IR 32

IR 46-R1 (Confirmation of Information in May 2024 Revised EIS)

Inclusion of information from Figure 2 of Attachment IR 46-R1 in the May Revised EIS:

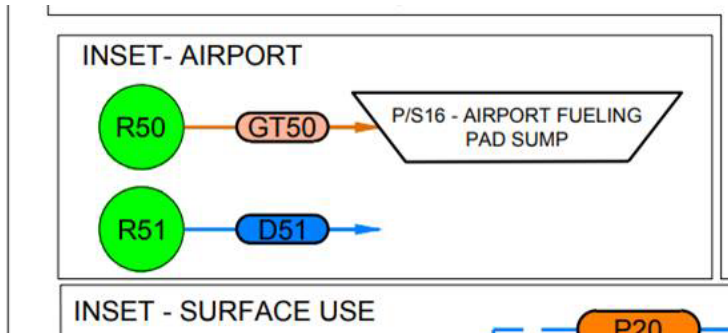
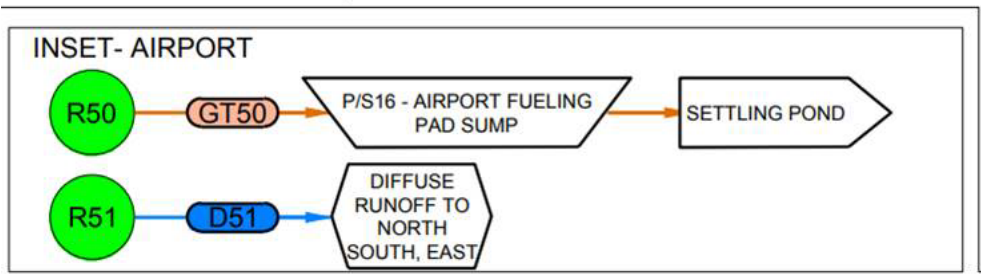
No.	Justification/Rationale	Follow up Information Request	NexGen Response
46	<p>Justification: The response to part one of the IR discusses, in part, runoff management for the Project airstrip and explosives storage area. Confirmation should be provided that any airstrip runoff containing glycol, fuel, or any other contaminants will be collected and managed appropriately to avoid any adverse effects on fish and fish habitat. In addition, the Proponent has committed to runoff collection and management in the explosives storage area, however, monitoring should be conducted to confirm the effective containment of explosives. The Proponent's response has not been added into the revised EIS.</p> <p>Parts two and three of the IR are accepted, however, ECCC reminds the Proponent that as outlined in Schedule 4 of the MDMER, subsection 4(1), all effluent, including total suspended solids, must meet the concentration-based limits, it must be within the minimum and maximum allowable pH, and it must not be acutely lethal.</p> <p>Rationale: The response to the airstrip aspect in IR part one will be accepted pending incorporation of the updates described in the response into the future revised EIS and on the Proponent adopting ECCC recommendations (next column).</p>	<ol style="list-style-type: none"> 1. Incorporate the updates described in the response into the future revised EIS, and; 2. Adopt the following recommendations into the Environmental Protection Plan/Program (as a commitment in the EA Follow up): <ol style="list-style-type: none"> a. Manage all potential airstrip contaminants and substances, including, but not limited to, glycol and fuel, appropriately to avoid any adverse effects to fish and fish habitat. Confirm that any airstrip runoff containing glycol, fuel, or any other contaminants will be collected and managed appropriately. b. Monitor the explosives storage area frequently for seepage and spills and to confirm effective containment of explosives. c. Identify and implement best practices for use, storage, and management of nitrogen-based explosives to avoid the introduction of explosives and their residues into the aquatic environment. 	<ol style="list-style-type: none"> 1. NexGen confirms that the requested changes associated with NexGen's response to IR 46-R1 were incorporated into the May 2024 Revised EIS. 2. NexGen understands that an EA follow up commitment may be requested by the CNSC.

Potential runoff from the airstrip was represented in the Site-Wide Water Balance Model by two runoff-generating elements: R50 (contained airport runoff [i.e., non-mineralized contact water collected from the apron pad]) and R51 (non-contained airport runoff [i.e., non-contact water from the maneuvering area]) (Draft EIS TSD XVIII [Site-Wide Water Balance and Water Quality Modelling Report], Figure 5). Element R50 would be a lined collection area, and runoff would be directed to an airport fueling pad sump. Water collected in the airport fueling pad sump would be periodically pumped out and trucked to the settling pond for reuse in the mill or for treatment prior to release. Runoff from Element R51 would release to the adjacent landscape, where best management practices for erosion and sediment control would be applied to minimize effects to the local environment. A visual representation of the site water management process for the Project airstrip is shown in Figure 2 of Attachment IR 46-R1. NexGen notes that as some additional context has been provided in Figure 2 that was not presented within the Draft EIS, the appropriate inset within Figure 5 of revised EIS TSD XVIII

NexGen confirms that the requested changes associated with NexGen's response to IR 46-R1 were incorporated into the May 2024 Revised EIS. For full context, below is the follow up request part 1 received from the CNSC, the response to IR 46-R1 provided by NexGen in the Round 2 IR response package (with key EIS notes related to revisions highlighted), and Figure 2 of Attachment IR 46-R1 noted in NexGen's response to IR 46-R1:

In summary, the changes committed to in the Revised EIS required the inclusion of elements of Figure 2 into Figure 5 of revised EIS TSD XVIII (Site-Wide Water Balance and Water Quality Modelling Report) and making the correction to element R52 in Figure 5 of revised EIS TSD XVIII to show non-contact water rather than contact water. The images below present where these changes have been made from Draft EIS to revised EIS.

Correction for Element R52 made in the May Revised EIS:

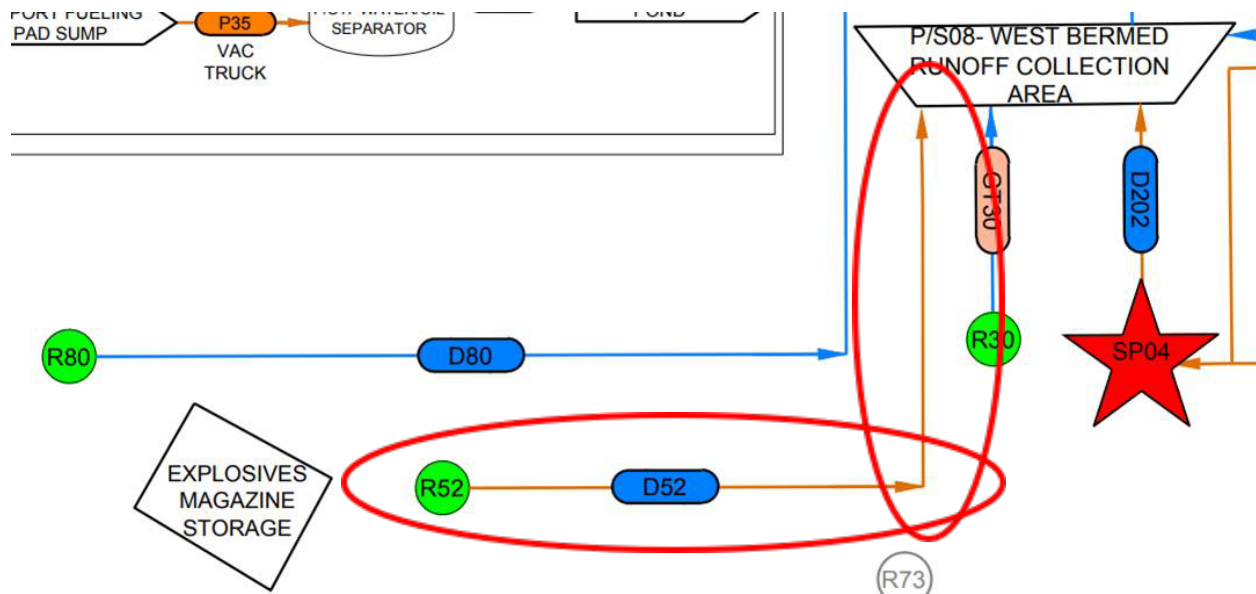
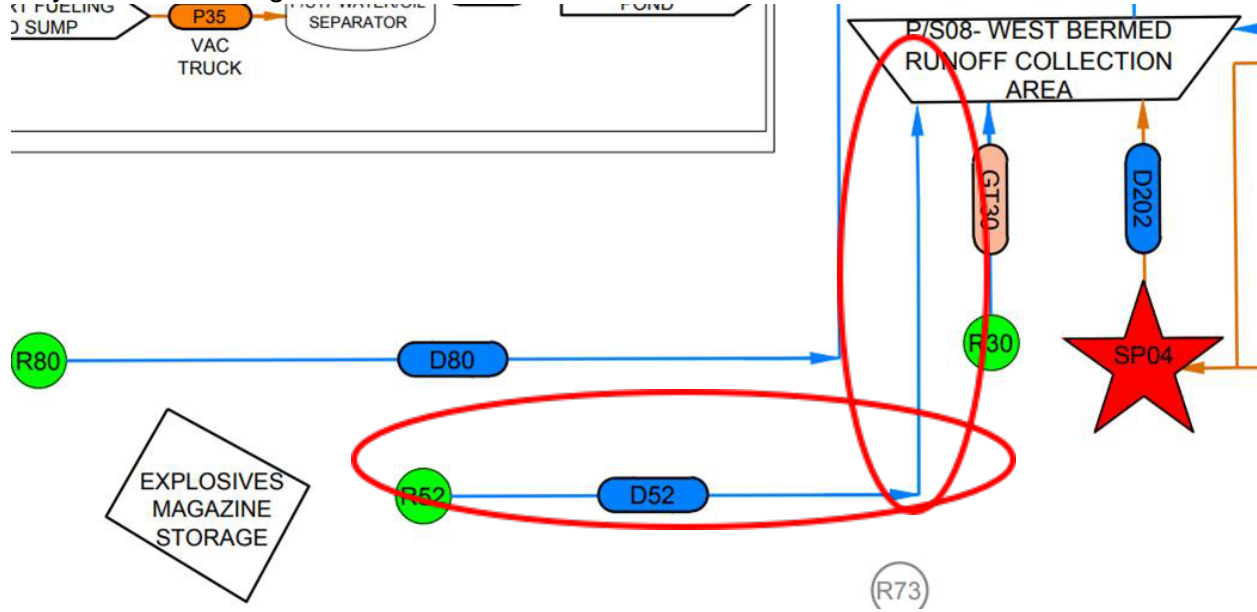
NexGen notes that Figure 5 of Draft EIS TSD XVIII incorrectly shows that Element R52 would contain mineralized contact water rather than non-mineralized contact water; this will be corrected in Figure 5 of revised EIS TSD XVIII.

NexGen notes that Figure 5 of Draft EIS TSD XVIII incorrectly shows that Element R52 would contain mineralized contact water rather than non-mineralized contact water; this will be corrected in Figure 5 of revised EIS TSD XVIII.

Figure 10.5-8: Application Case Cobalt Concentration in Patterson Lake North Arm – West Basin, Patterson Lake South Arm, Forrest Lake – North Basin, and Beet Lake

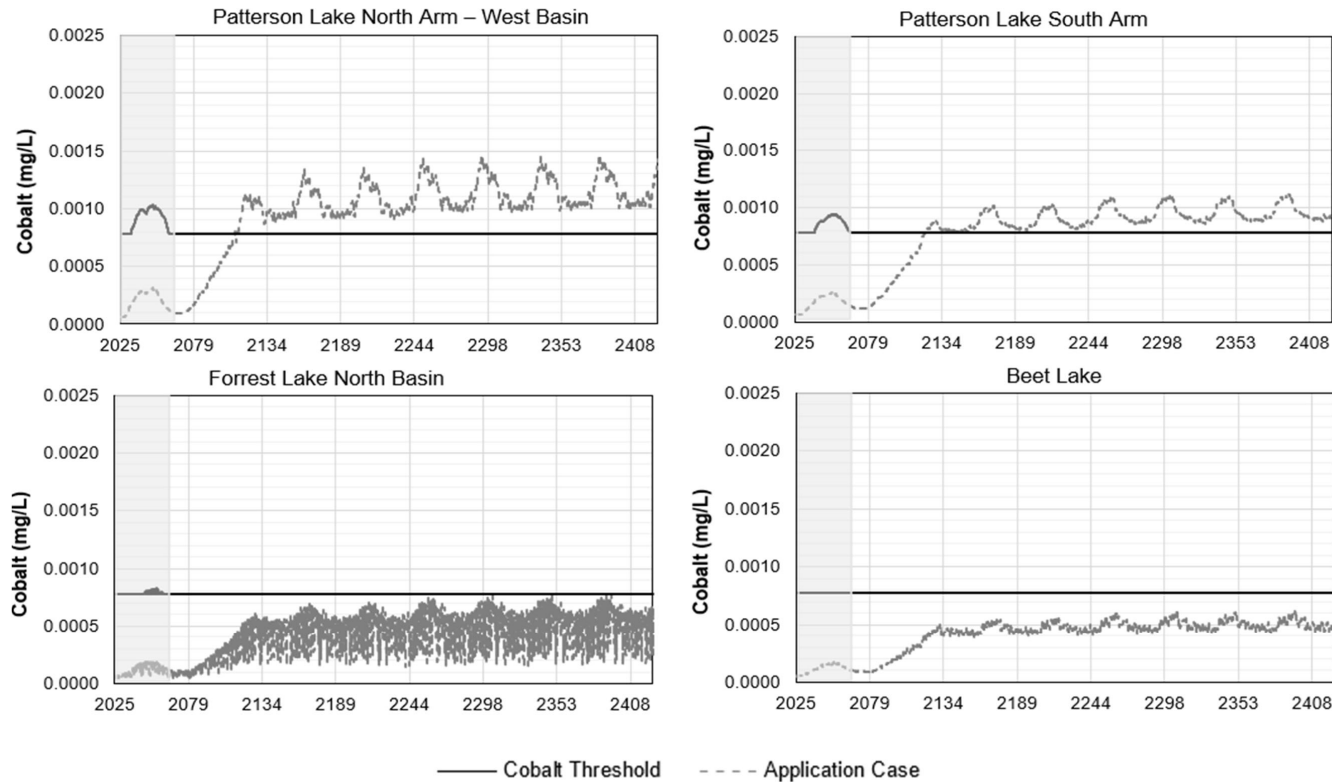
Commented [LM35]: Change related to IR 89-R1 from 22 October 2024 comment table from CNSC.

Figure 10.5-19: Reasonably Foreseeable Development Case Copper Concentration in Patterson Lake North Arm – West Basin and Patterson Lake South Arm

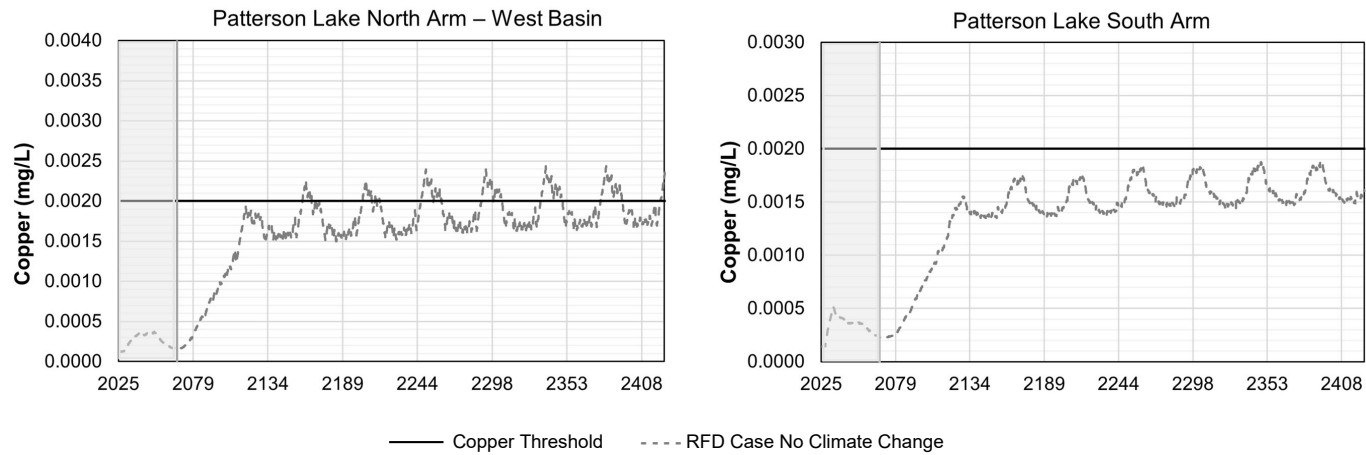
Commented [LM38]: Change related to IR 89-R1 from 22 October 2024 comment table from CNSC.

Part 1

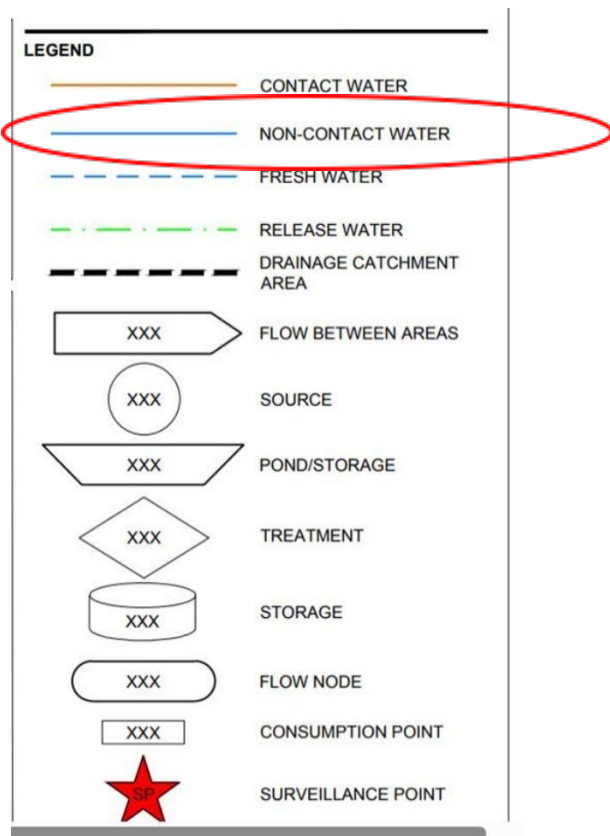
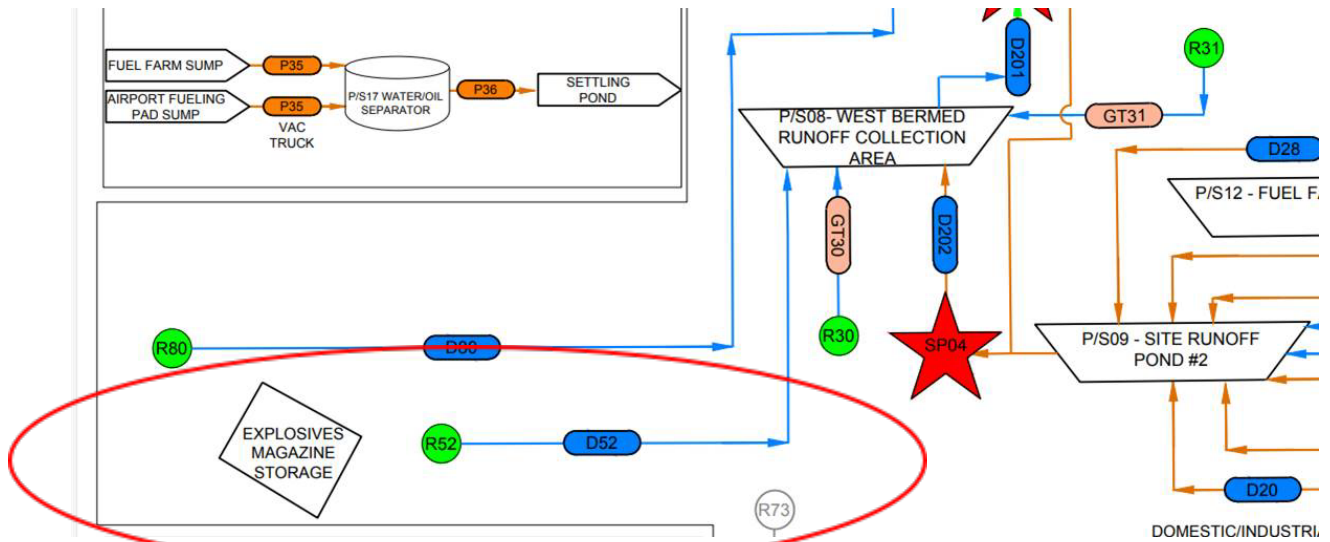
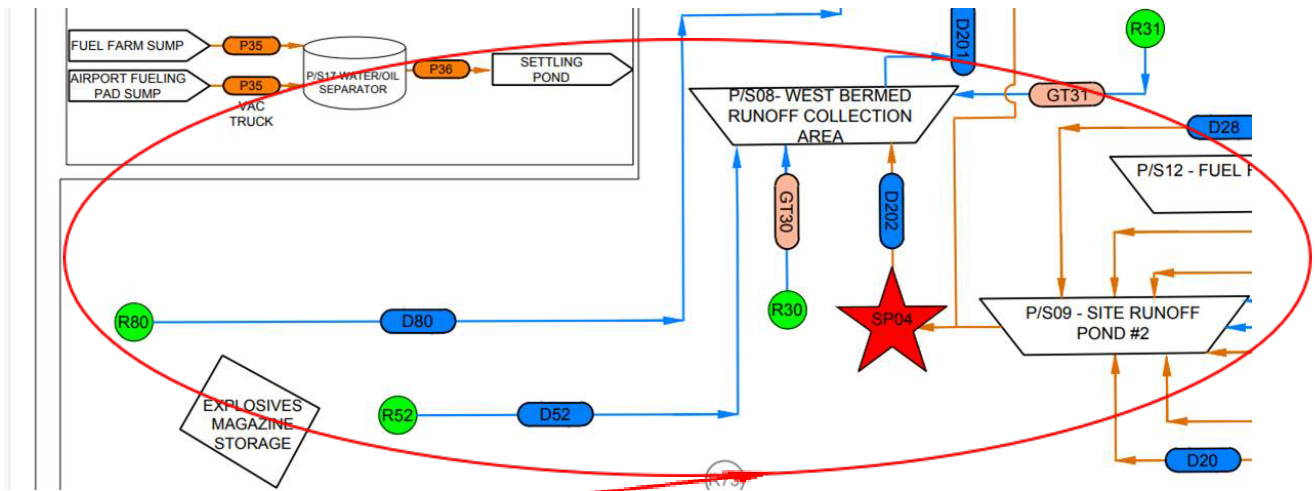
With respect to changes in the EIS to address part 1 and part 2 of IR 244-R1, NexGen confirms that edits were already incorporated in the May Revised EIS. Please see below the changes that were presented in the May Revised EIS, with identifiers (i.e., circles, highlighting, text box) included to show the necessary aspects.

Figure shows that all water inputs to the west bermed runoff collection area that do not go through a Final Discharge Point represent non-contact water. The only contact water input to the west bermed runoff collection area is from site runoff pond #2, which as shown, would go through a surveillance point (in this case a Final Discharge Point Surveillance Point)
